City West Cable Tunnel

Submissions Report

September 2006

EnergyAustralia

Figure 4.2 Modified Blackwattle Place construction site layout

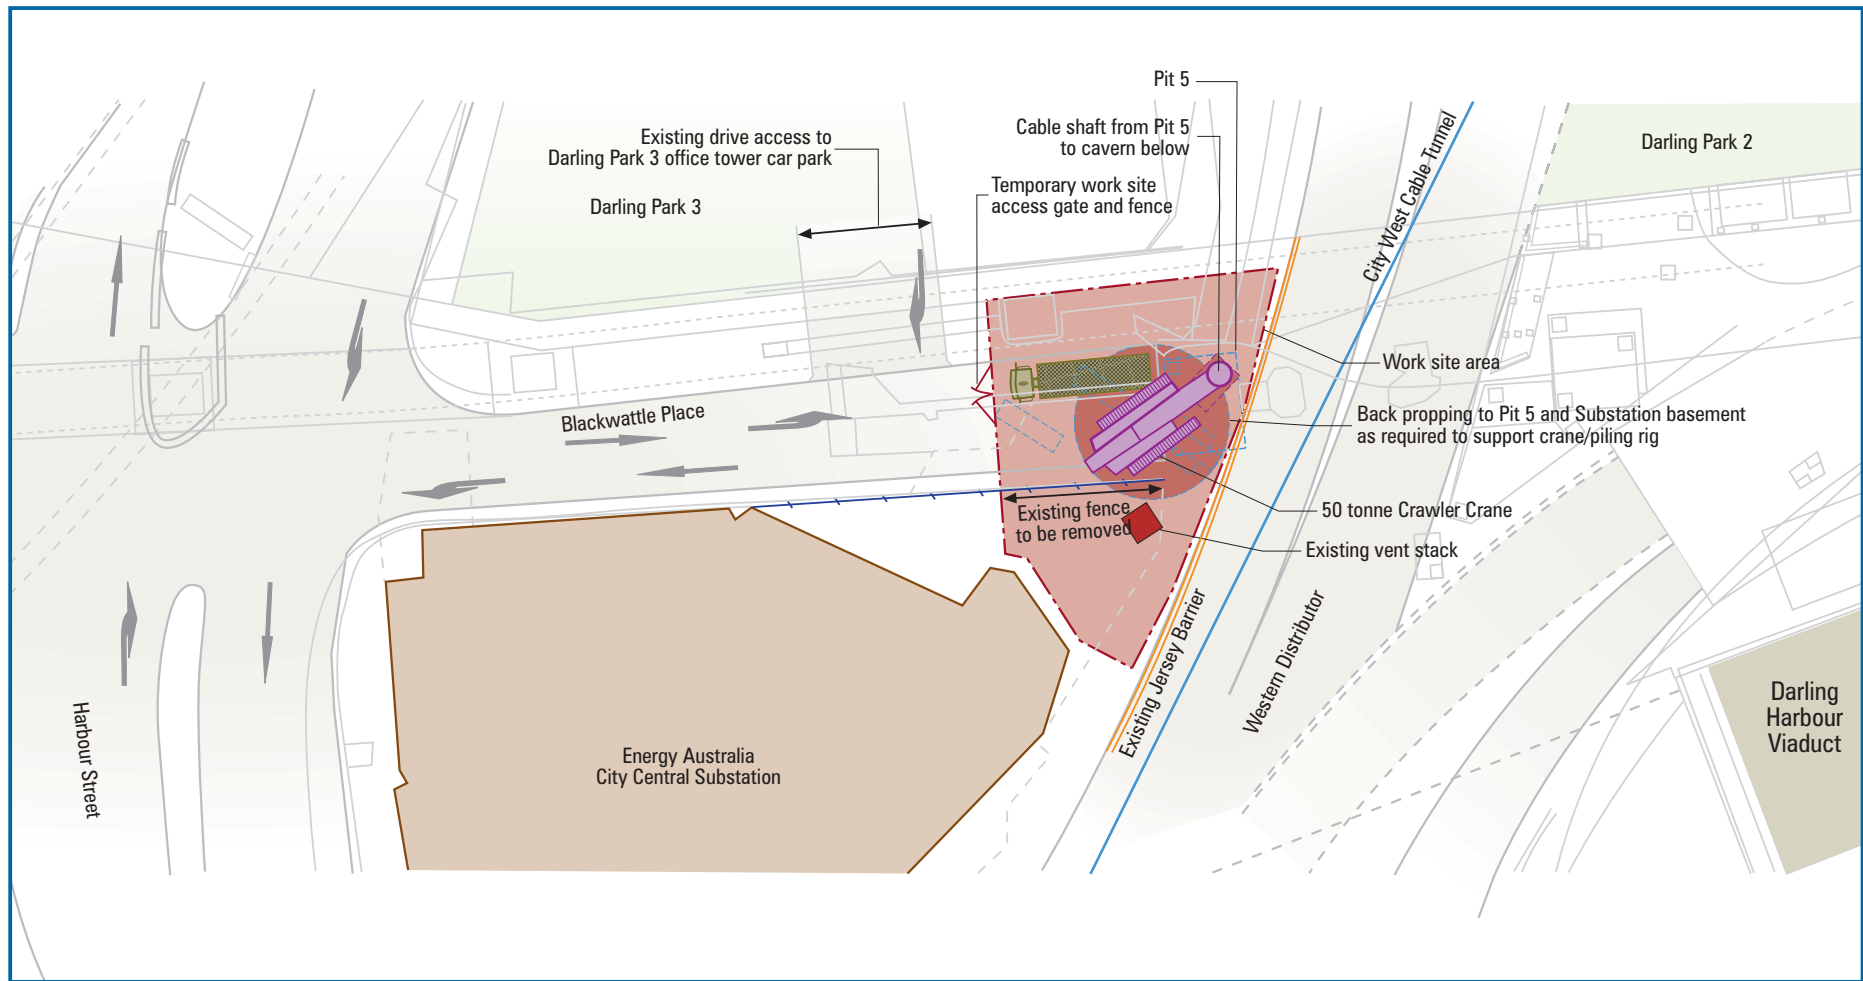
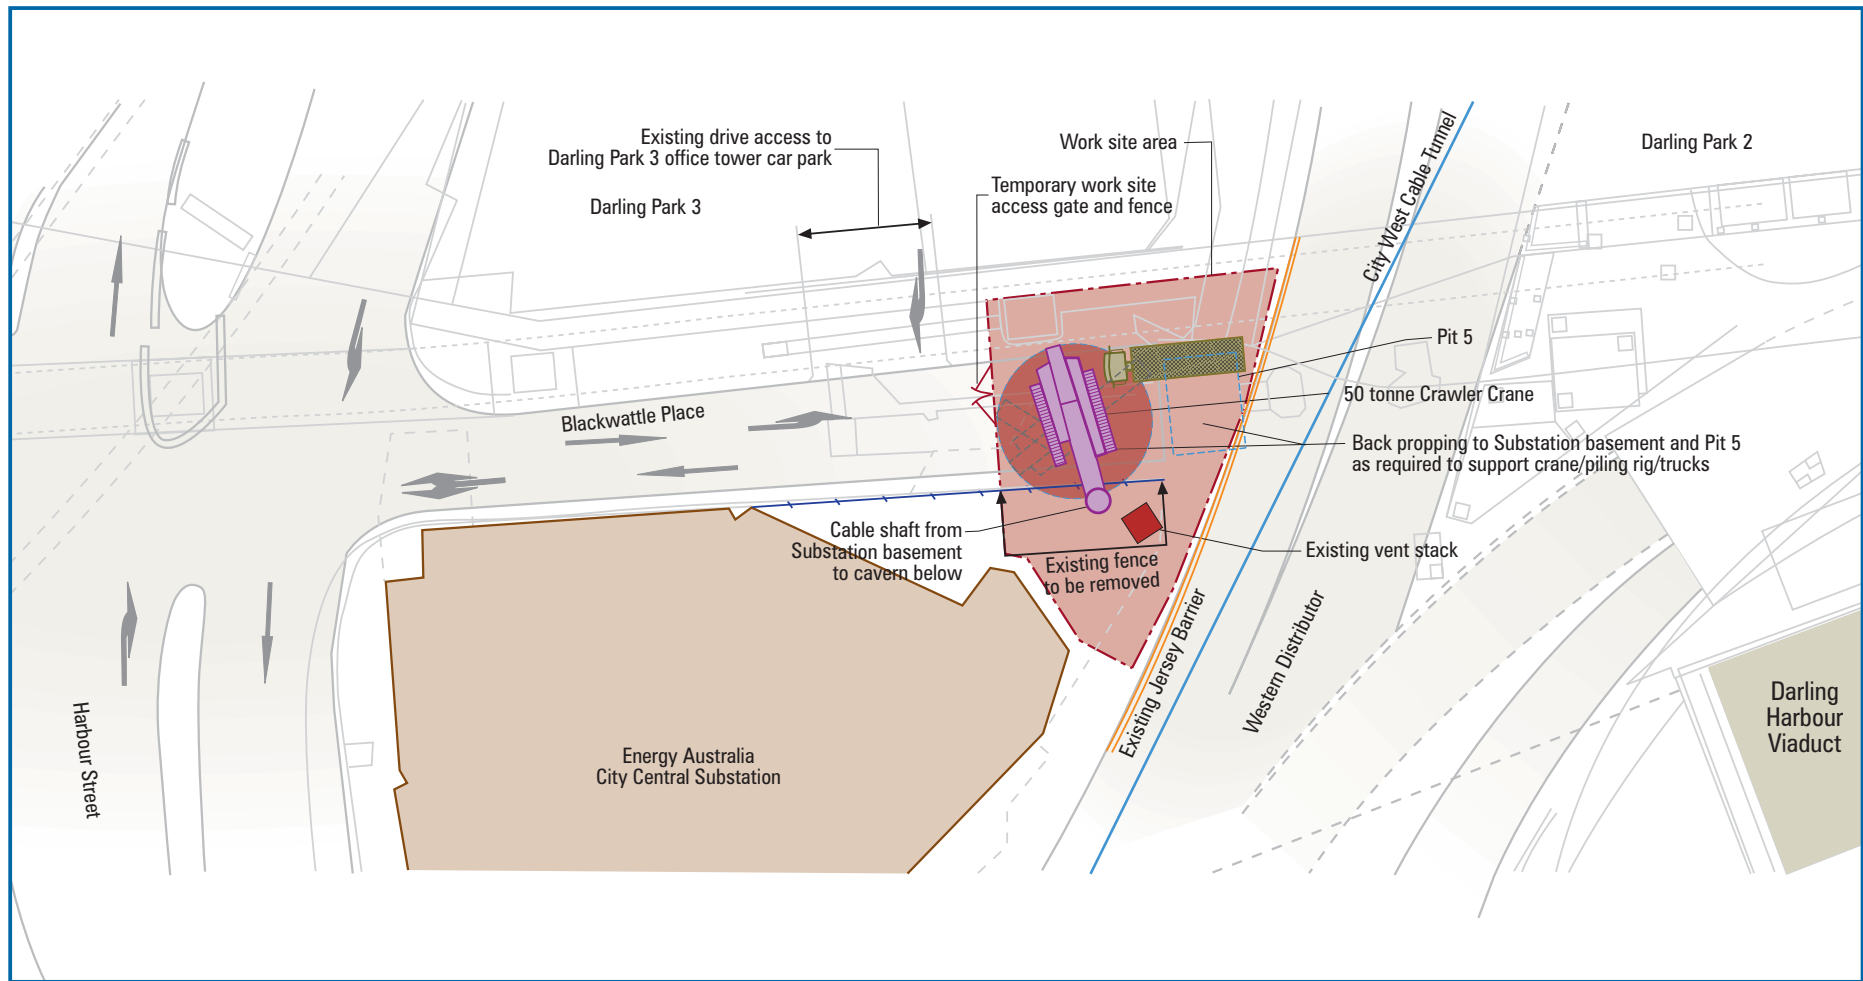
EnergyAustralia has further investigated the design of the City Central Substation connection. These investigations have identified the option of boring the connection shaft from within the basement levels of the City Central Substation. This modified design could potentially reduce construction impacts at this location. Details of the design proposed in the Environmental Assessment, and the modified design are provided below.

The construction site for the modified would also be located at the eastern end of Blackwattle Place as originally proposed in the Environmental Assessment. However, the City Central Substation connection would form part of the substation proper by means of a shaft located within the roof and floor slab of the cable basement. *Figure 4.2* provides an indicative layout of the construction site.

A lockable gatic cover or concrete cover would be installed at ground slab level, outside the substation (roof of the cable basement area); this would facilitate access in the case of emergency repairs to the cables. At the floor slab of the cable basement (inside the substation) the shaft would rise above the floor in order to turn the cables from the shaft into the substation proper and then onto the respective jointing or termination locations; this approach would assist with waterproofing and sealing to maintain the integrity of the substation basement.
